GNRO-2013/00089

Subject: Emergency Plan, Revision 70  
Grand Gulf Nuclear Station, Unit 1  
Docket No. 50-416  
License No. NPF-29

**SUMMARY AND ANALYSIS OF THE  
GGNS EMERGENCY PLAN CHANGES**

**EMERGENCY PLAN, REVISION 70**

**TABLE 2-3  
Permanent Resident Population and Vehicles by PAS/PAA**

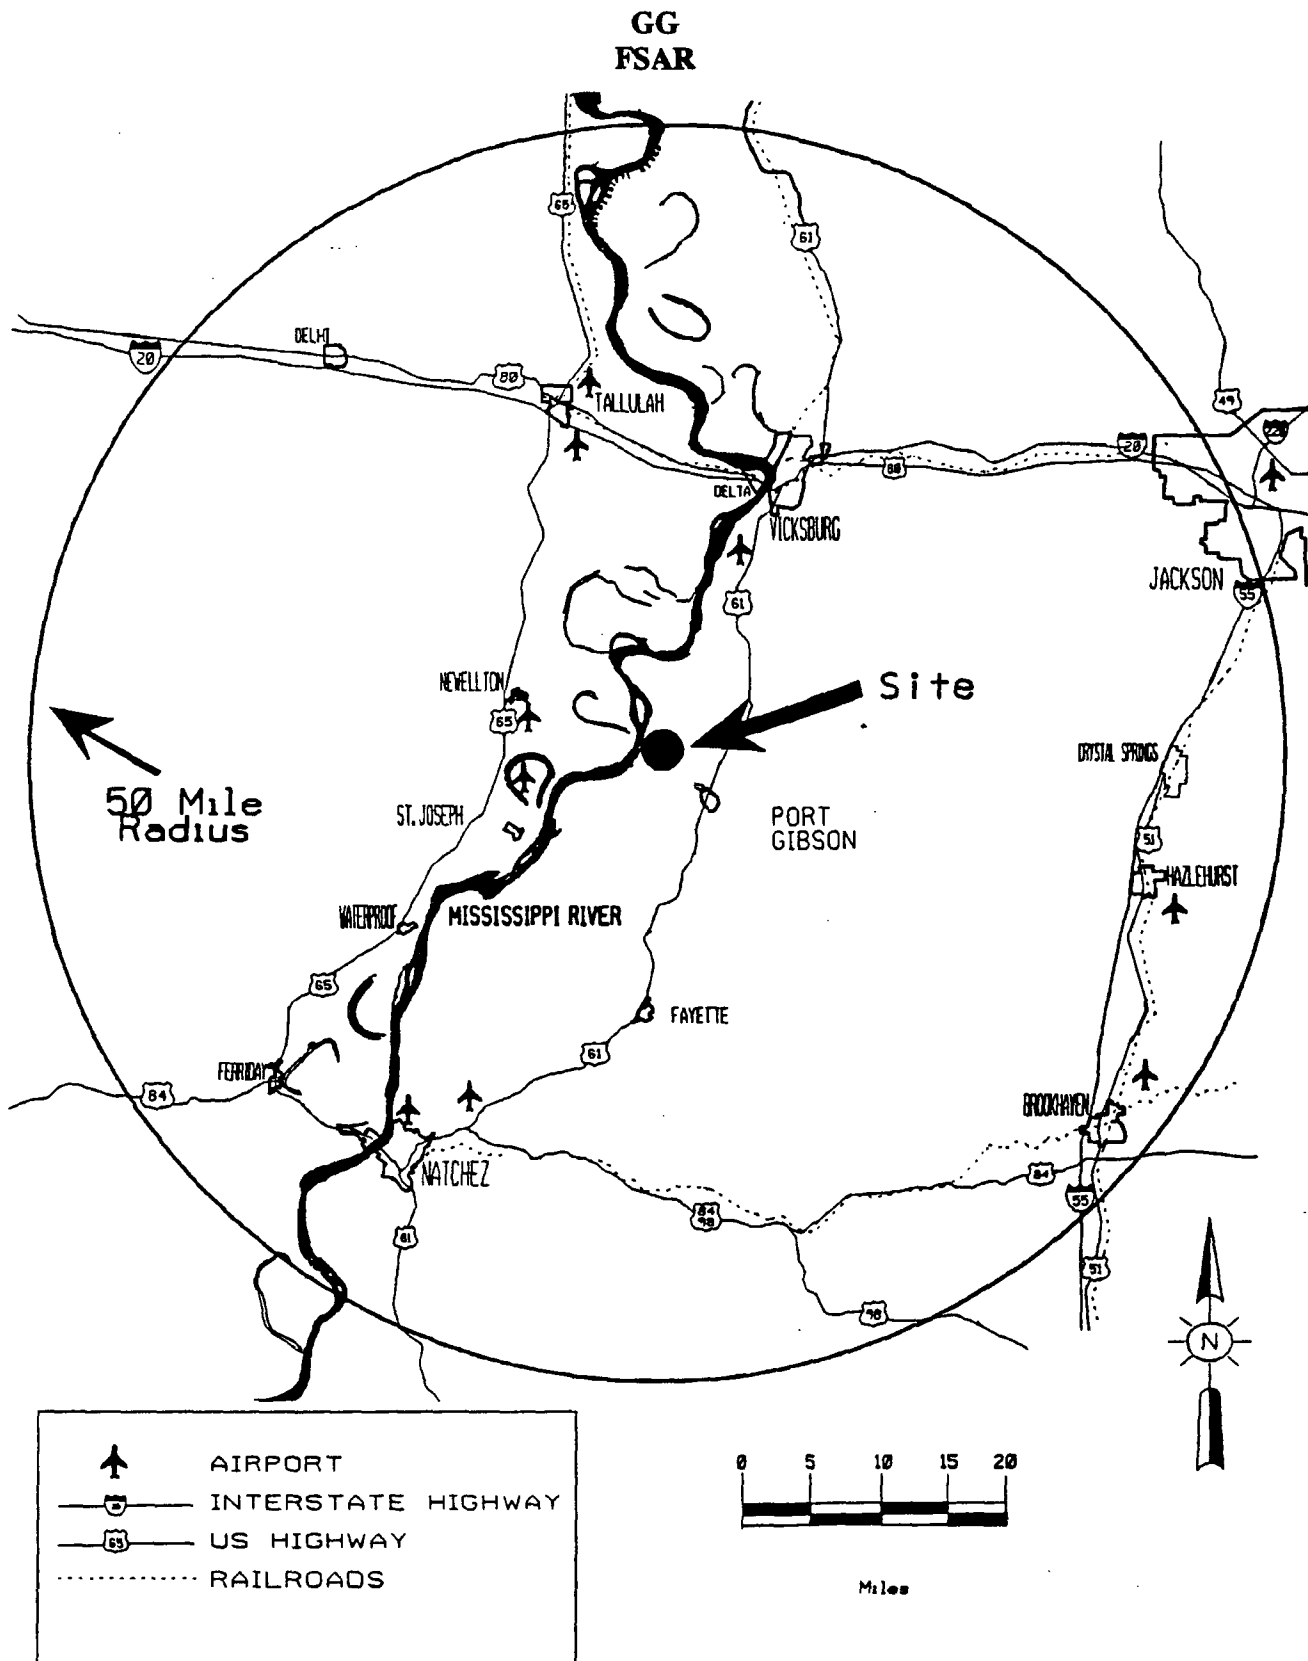
1. Page 2-10. Update Table 2-2 (Resident Population Distribution) with new permanent resident population numbers based on 2012 GGNS ETE.
2. Page 2-10a. Add Table 2-3 Permanent Resident Population by Protective Action Areas.

Permanent Resident Population Distribution  
FIGURE 2-3

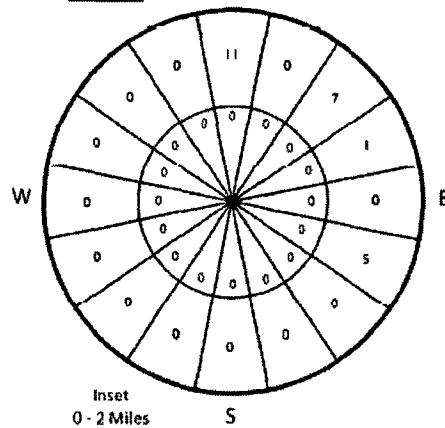
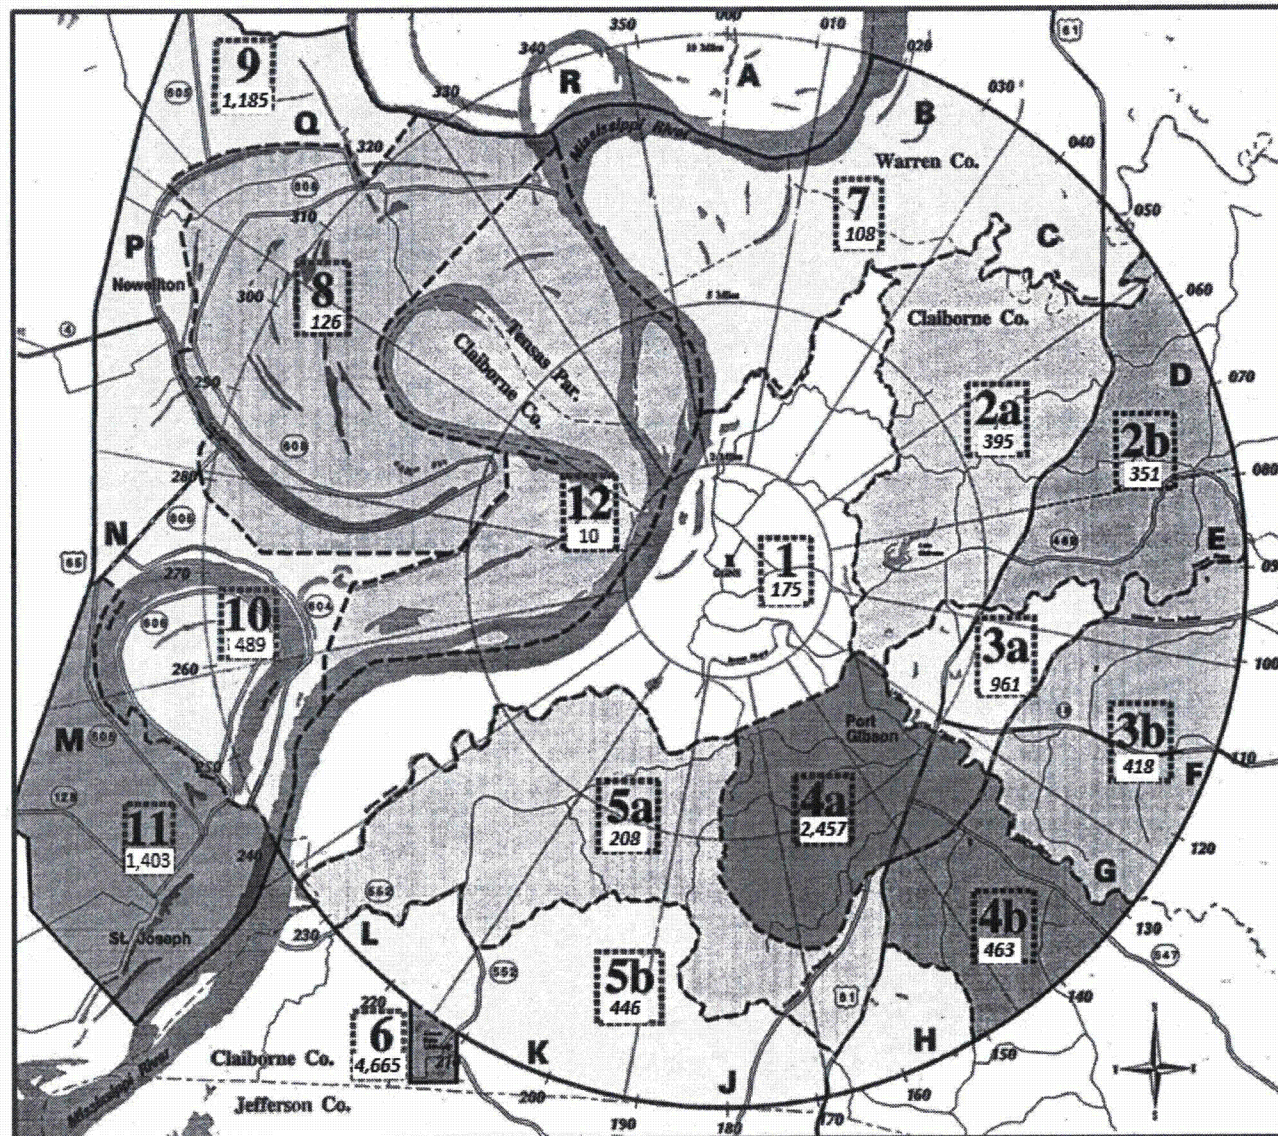
3. Page 2-13. Replace figure 2-3 (Permanent Resident Population Distribution) with updated figure from the 2012 GGNS ETE.
4. Page 2-14. Update Figure 2-14 evacuation zone population numbers with revised numbers from the 2012 GGNS ETE.

Update Table 2-2 (Resident Population Distribution) with new permanent resident population numbers based on 2012 GGNS ETE, add Table 2-3 Permanent Resident Population by Protective Action Areas, replace figure 2-3 (Permanent Resident Population Distribution) with updated figure from the 2012 GGNS ETE, Update evacuation zone population numbers with revised numbers from the 2012 GGNS ETE and replace entire Appendix E (Evacuation Time Estimate) with updated 2012 GGNS ETE. This change incorporates the 2012 GGNS Evacuation Time Estimate that was completed in November of 2012 and was submitted to the NRC in December of 2012 in accordance with 10 CFR 50 Appendix E section IV (Reference CNRO2012-00013). The 2012 ETE determined that the population in the GGNS Emergency Planning Zone decreased by 10.3% from the previous estimate from 2010. The use of the most recent decennial census data in the ETE analysis is consistent with 10 CFR 50 appendix E IV 4-6. conformance with NEI 99-01 Rev 5 AND the SER. The time estimates show a decrease in population and a general decrease in evacuation times. The addition of the new ETE information will not decrease the effectiveness of the GGNS Emergency Plan.

**FIGURE 5-3**  
5-33

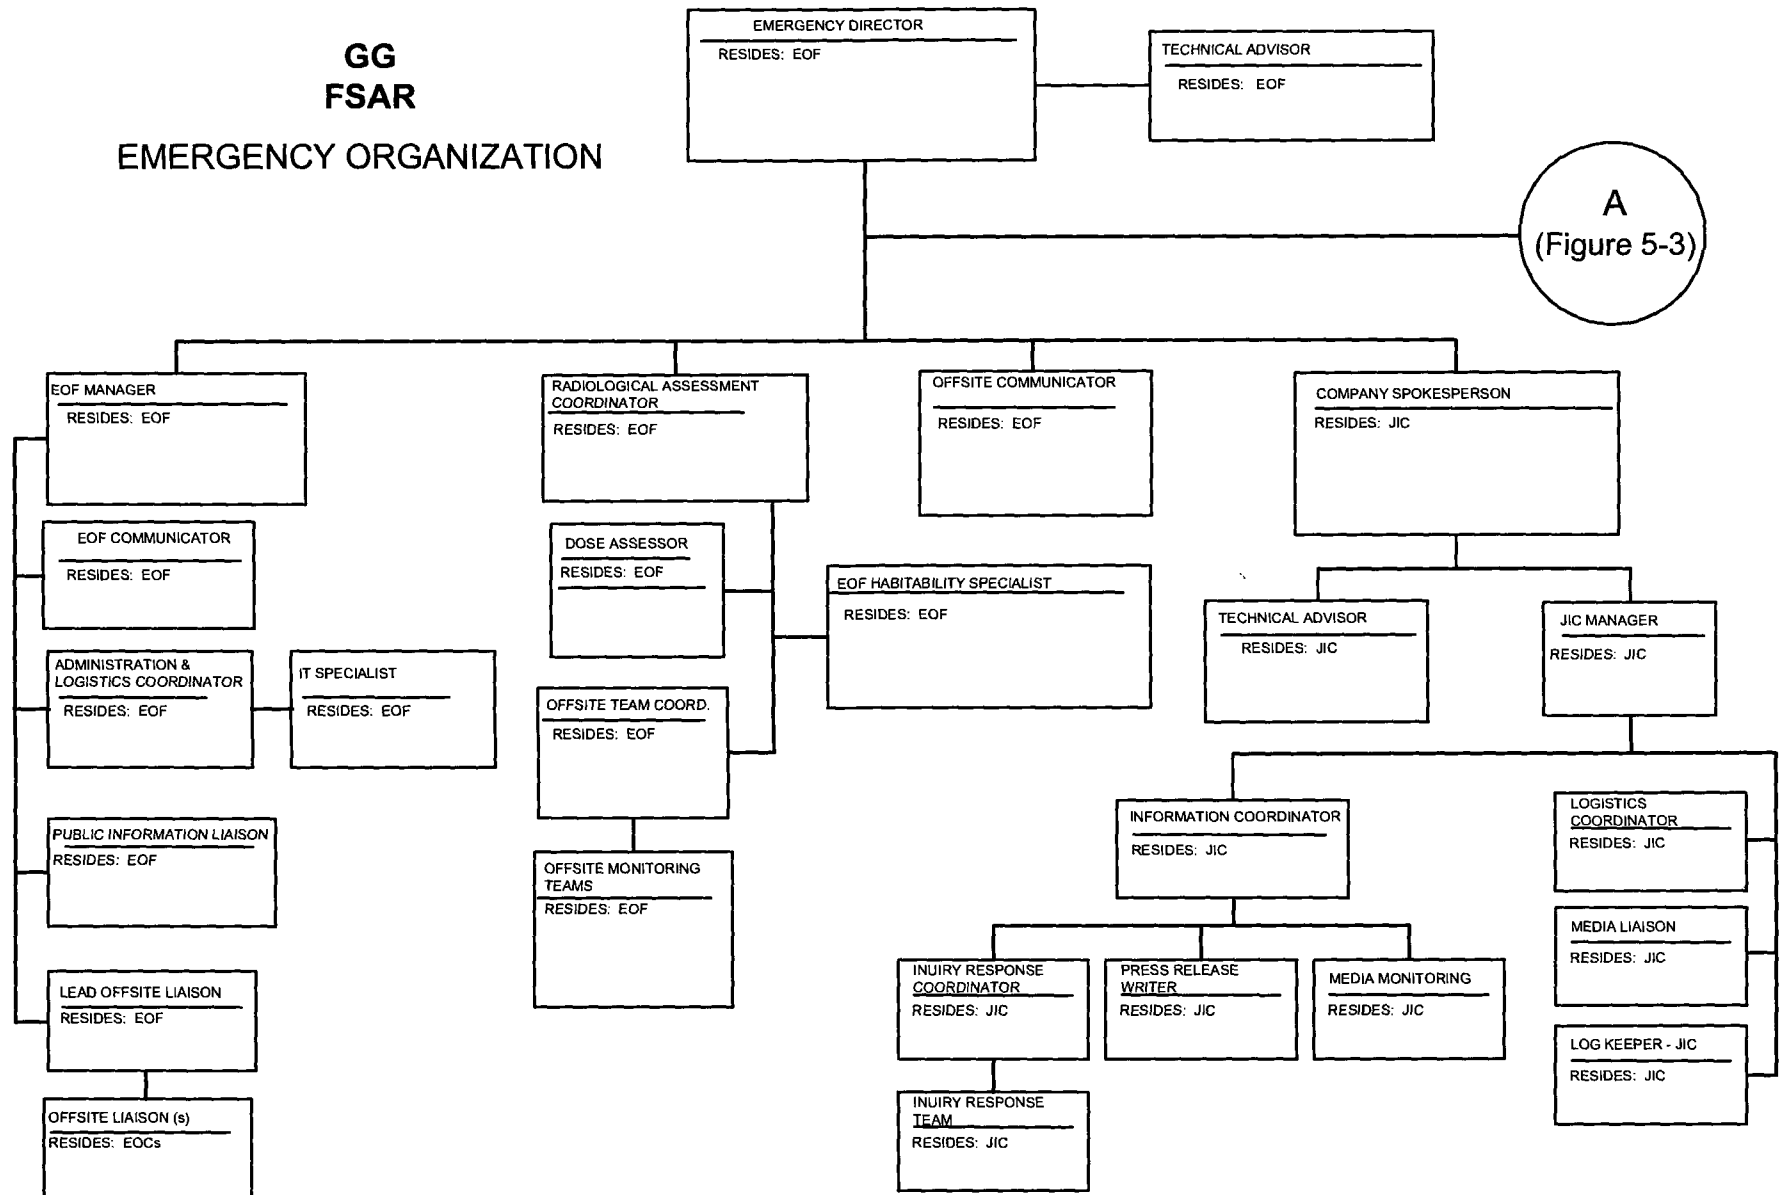
7. Page 5-4. Add reference to EN-TQ-110-01 for ERO position prerequisites.
8. Pages 5-33 & 5-34. Removed personnel who normally fill ERO positions from tables.

Add reference to EN-TQ-110-01 for ERO position prerequisites and remove the personnel who normally fill ERO positions from tables 5-33 & 5-34. Tables 5-33 and 5-34 are ERO org Charts that include ERO titles, locations and the department/title that normally fills that ERO position. In the past ERO personnel were assigned by departments but when EN-TQ-110-01 was issued in June 2013 it included prerequisites for ERO assignment and ERO personnel are now assigned by prerequisites. Identifying the department/title that normally fills ERO positions is no longer needed. This change is consistent with the planning standard in 10 CFR 50.47(b)(2) - *Onsite Emergency Organization - The process for timely augmentation of on-shift staff is established and maintained.* The standard does not specify how ERO assignments are made but does list position expertise in the informing criteria Table B-1 of NUREG 0654 Section II B. The prerequisites listed in EN-TQ-110-01 are consistent with the position expertise in table B-1.

**JOINT INFORMATION CENTER  
LAYOUT  
FIGURE 7-9**

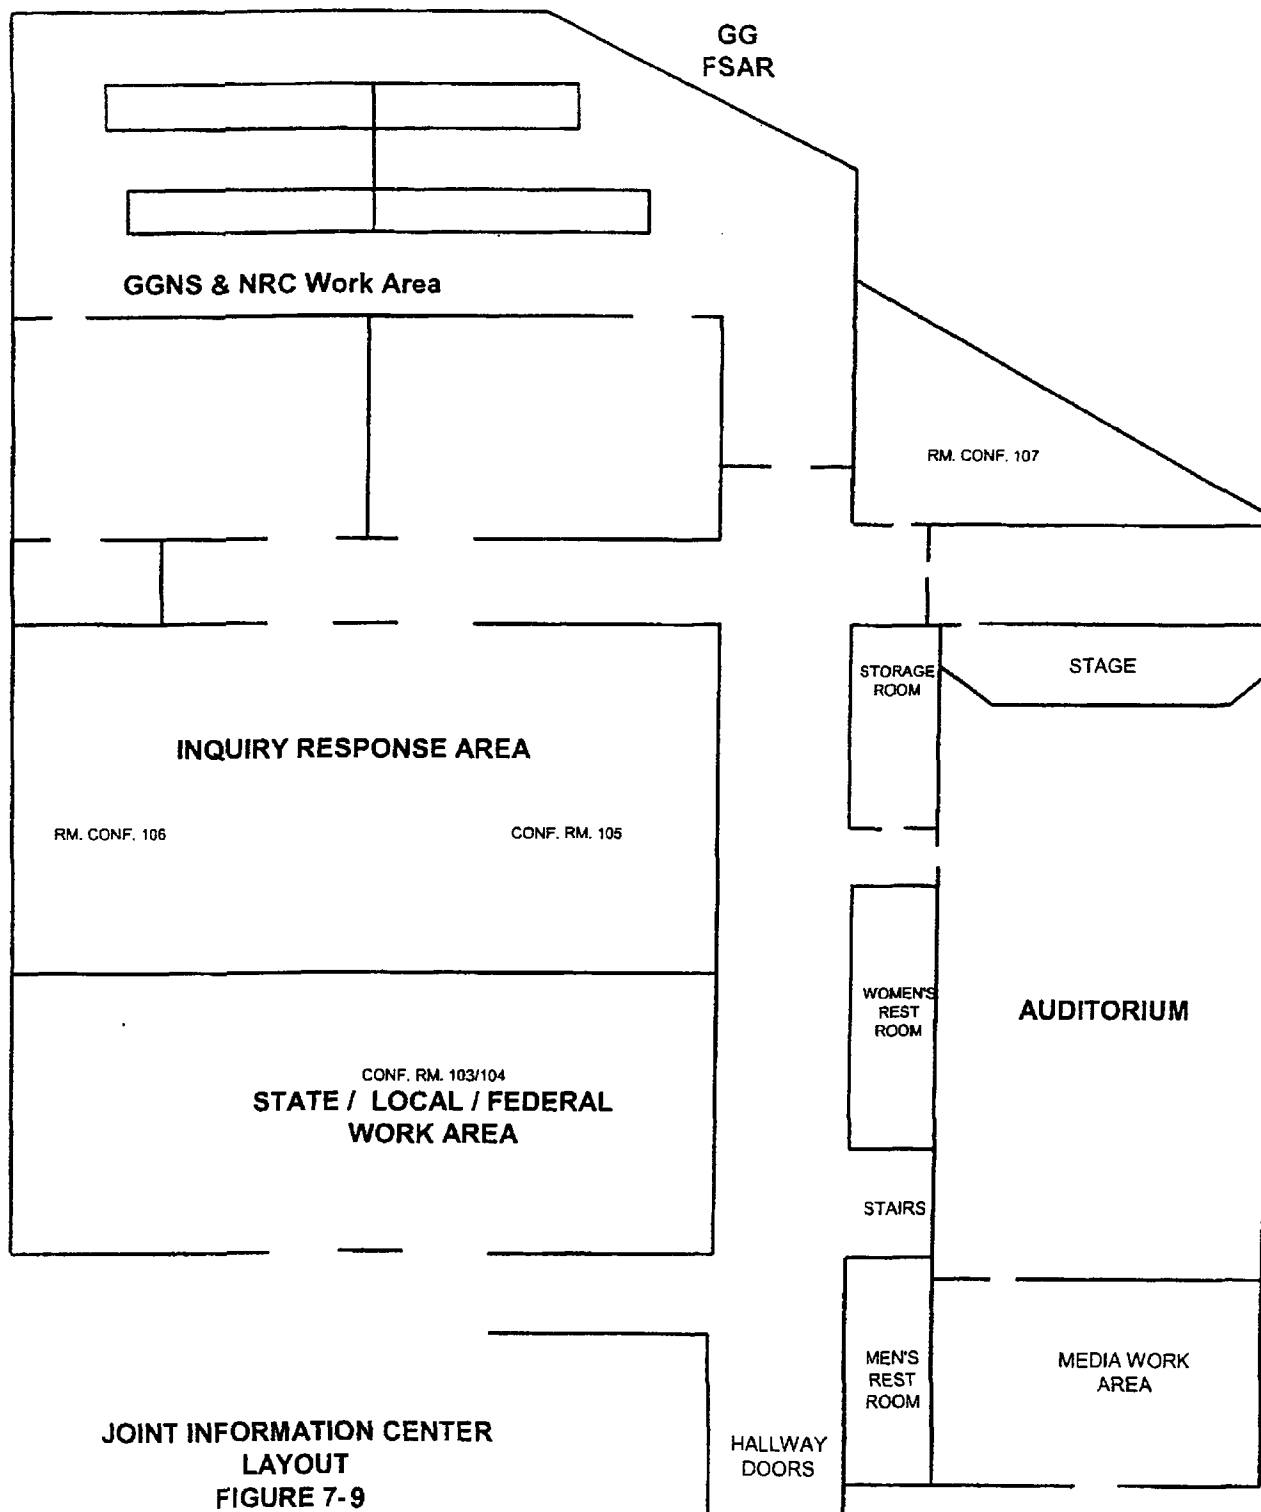
12. Page A-3. Change in position title.
13. Page A-10. Correct the title of Figure 7-9 to Joint Information Center Layout.
14. Page D-1. Correct title of Claiborne County Hospital.
